MASONRY WALL DESIGN

IOWA ELECTRIC LIGHT AND POWER COMPANY
DUANE ARNOLD ENERGY CENTER

TECHNICAL EVALUATION REPORT

NRC DOCKET NO. 50-331

Figure 1. Typical Block Wall Support Details

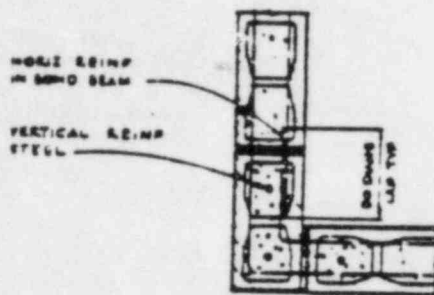
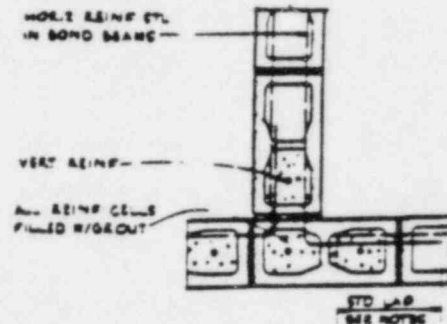
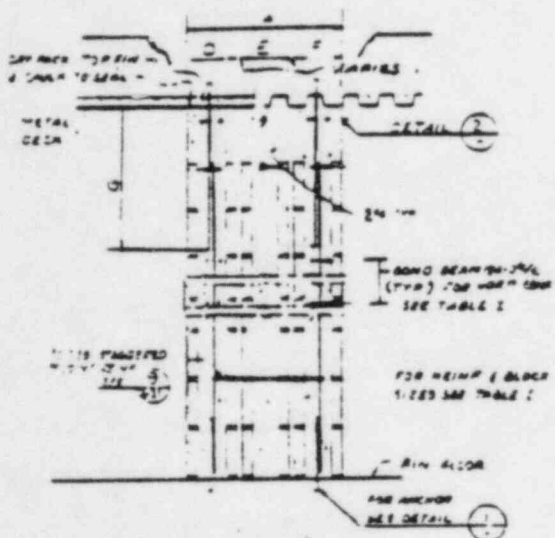
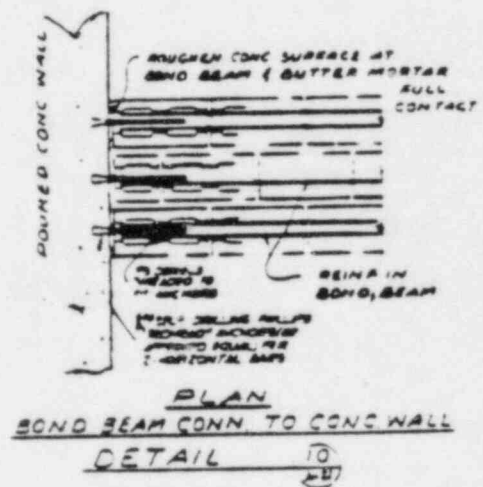
- b. For those walls in which the calculated stress exceeded 40 ksi, please provide the following information for each wall: calculated stress, wall's dimensions and thickness, type and spacing of reinforcement, and connection details at the boundary. Also, provide sample calculations (with necessary explanation to make them understandable) illustrating the analytical procedures used in obtaining the stress values.

- b. The Licensee provided the calculated stresses in the horizontal reinforcement along with the wall dimensions, thickness, the type and spacing of reinforcement, and the boundary conditions used for all walls having calculated stress higher than 40 ksi. Typical construction details are illustrated in Figures 1 and 2. Sample calculations were also provided for review.

Figure 3. Typical Stress-Strain Curves for Plain Wire [16]

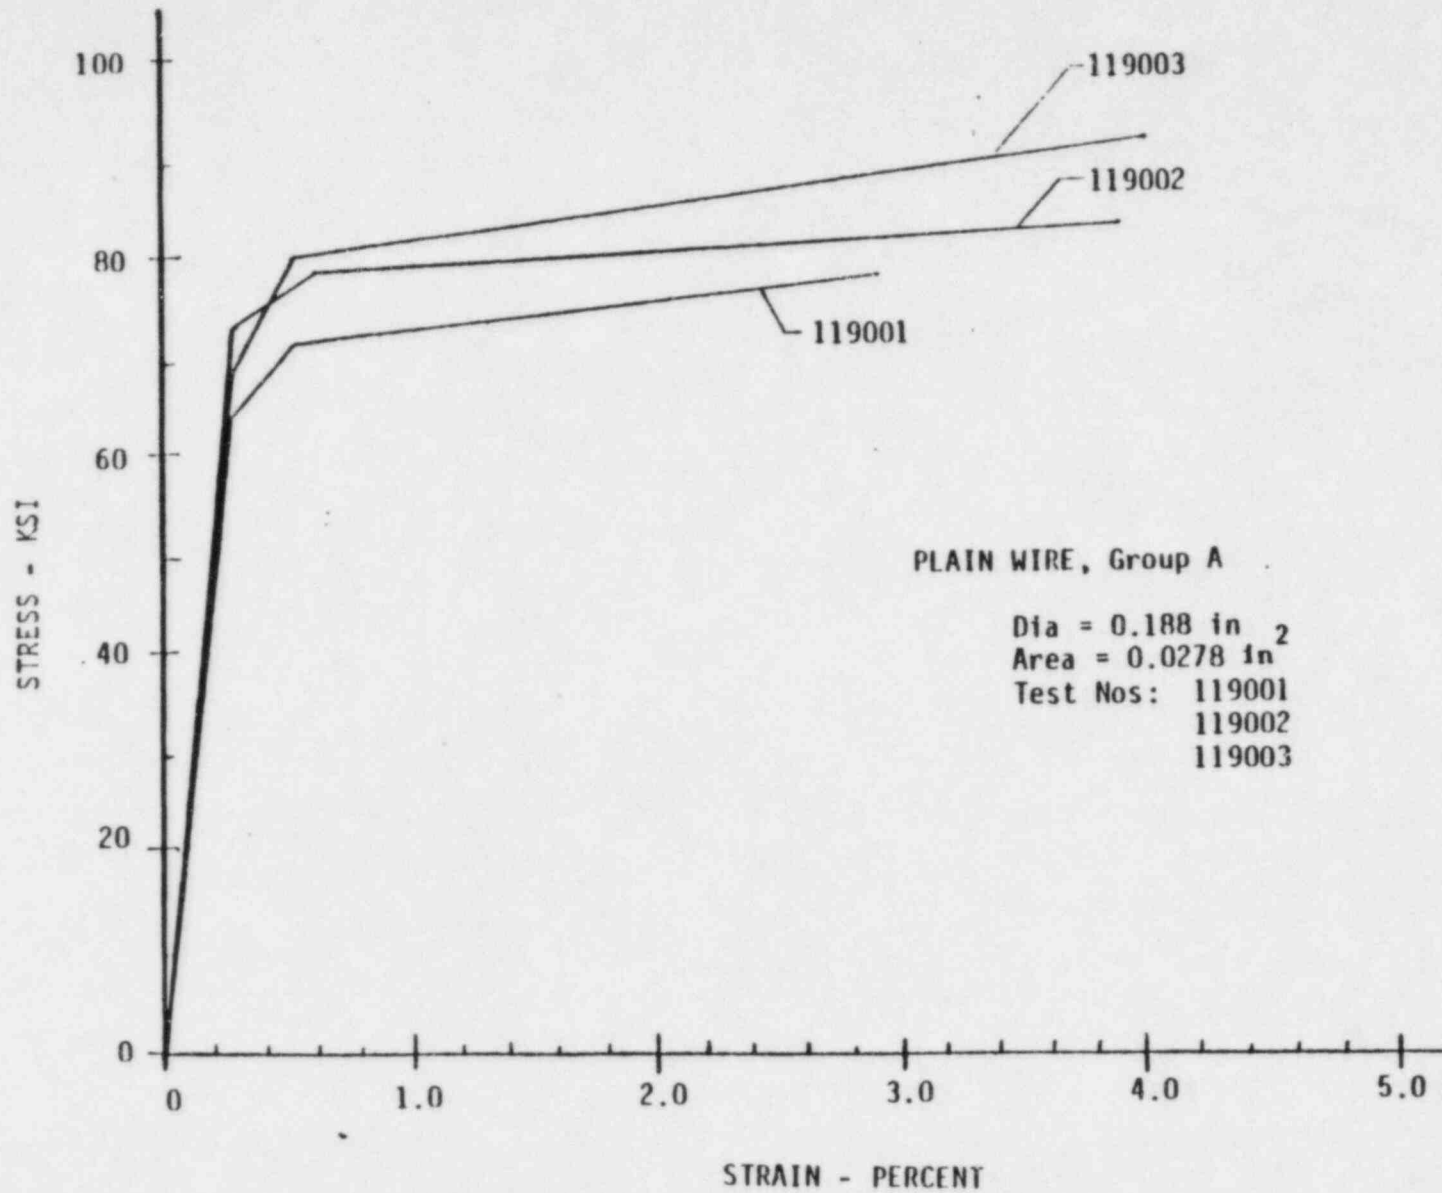
- c. Provide the stress-strain relationship of the type of joint reinforcement used in the plant. If test data from the manufacturer are not available, it is recommended that some simple tests be conducted to obtain this relationship.

- c. The Licensee provided stress-strain relationships for plain and deformed wire obtained from tests (manufacturers' data [16, 17]). These curves are given in Figures 3 and 4. The curves shown in Figures 3 and 4 represent the joint reinforcement types found at the plant. Table 1 summarizes the data in these figures.
